Re: Salinas Valley – 180/400 Foot Aquifer Subbasin (No. 3-004.01) – Response to DWR 2025 Periodic Review – Additional Information Request

Response to DWR Additional Information Request

Figure 9. 2040 500 mg/L Chloride Contours Comparison of Preferred BGRP Alternative to Baseline Scenario and Minimum Threshold

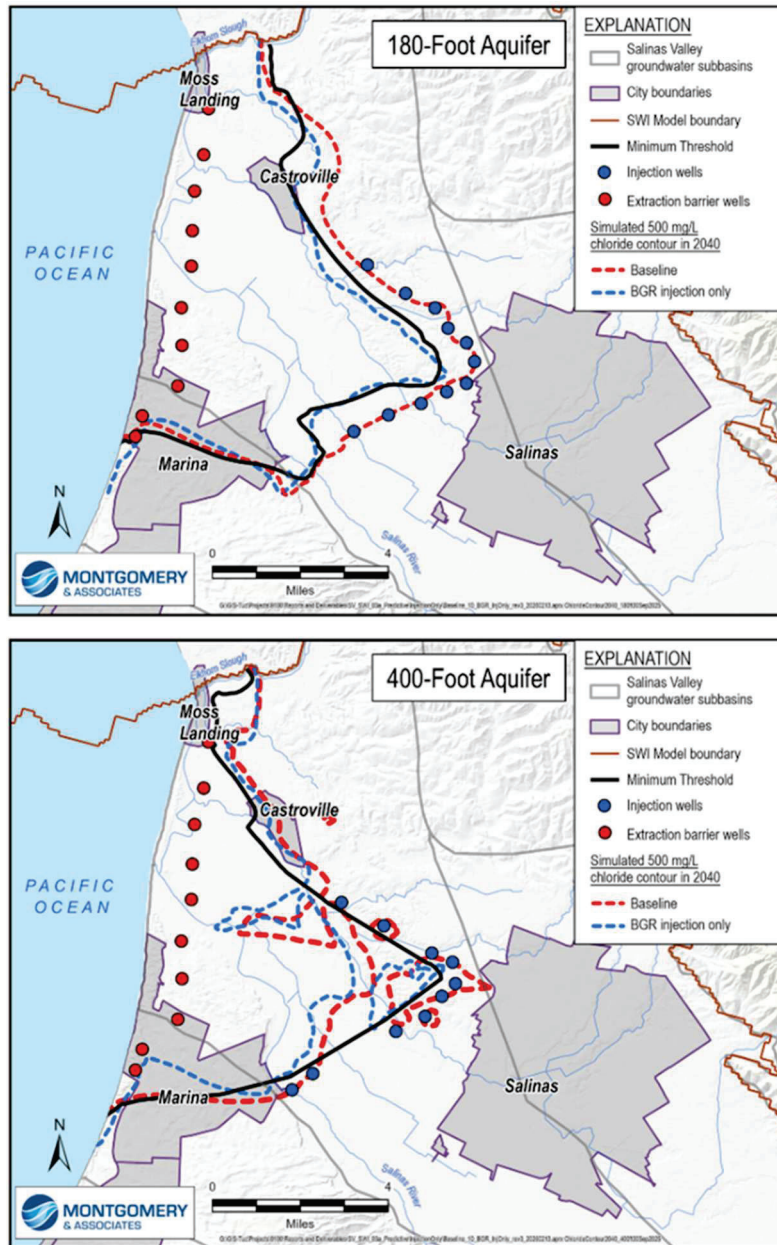
4.2.2 DWR Question: If the Brackish Groundwater Restoration Project does not get selected for implementation, what contingency project(s) and/or management action(s) will be implemented to halt and mitigate seawater intrusion?

The Injection Only BGRP is effective at reversing seawater intrusion and avoiding undesirable results. Figure 9 shows that in both the 180-Foot and 400-Foot Aquifers, the 2040 extent of seawater intrusion is close to the minimum threshold. Modeling with the SWIM shows how the BGRP Injection Only results in lower chloride concentrations than the Baseline Scenario. This demonstrates the effectiveness of the coastal extraction wells, which both draw existing seawater intrusion toward the coast and prevent any new seawater intrusion.

Figure 15. State and Local Small Water Systems (Adapted from County of Monterey map⁴)

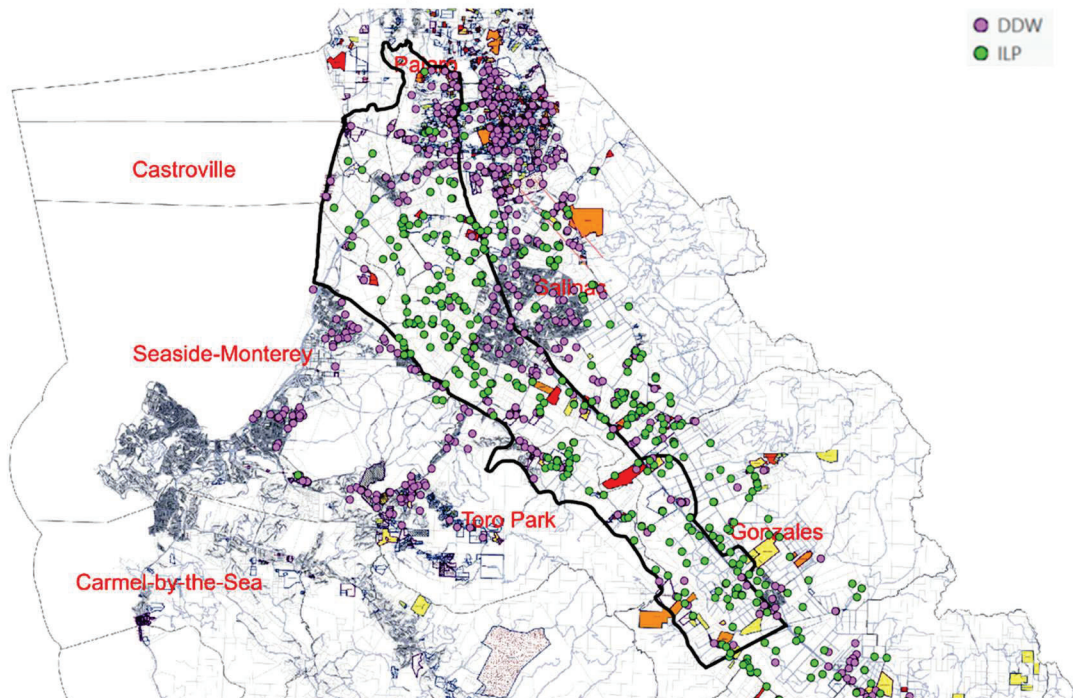
4.4.1 DWR Question: Provide rationale for excluding small water systems from the evaluation of degraded water quality in the Subbasin.

With respect to DWR's second request on degraded water quality, the 2020 GSP stated that state and local small water systems, which are monitored by the EHB extended period, would be included in the assessment of degraded water quality in the 180/400 Subbasin. These water systems are shown below on the top half of Figure 15. The bottom half of Figure 15 shows these water systems overlapped with the drinking water system wells that report to the Division of Drinking Water (DDW) as the purple dots and Irrigated Lands Program (ILP) on-farm domestic wells as the green dots. In GSP Amendment 1, this statement was removed because the DDW and ILP monitoring provides sufficient spatial coverage of the Subbasin as shown on Figure 1. Additionally, the EHB mainly samples for nitrate and arsenic, which are widely sampled through the DDW and ILP, and the data would require significant effort to organize and incorporate annually.
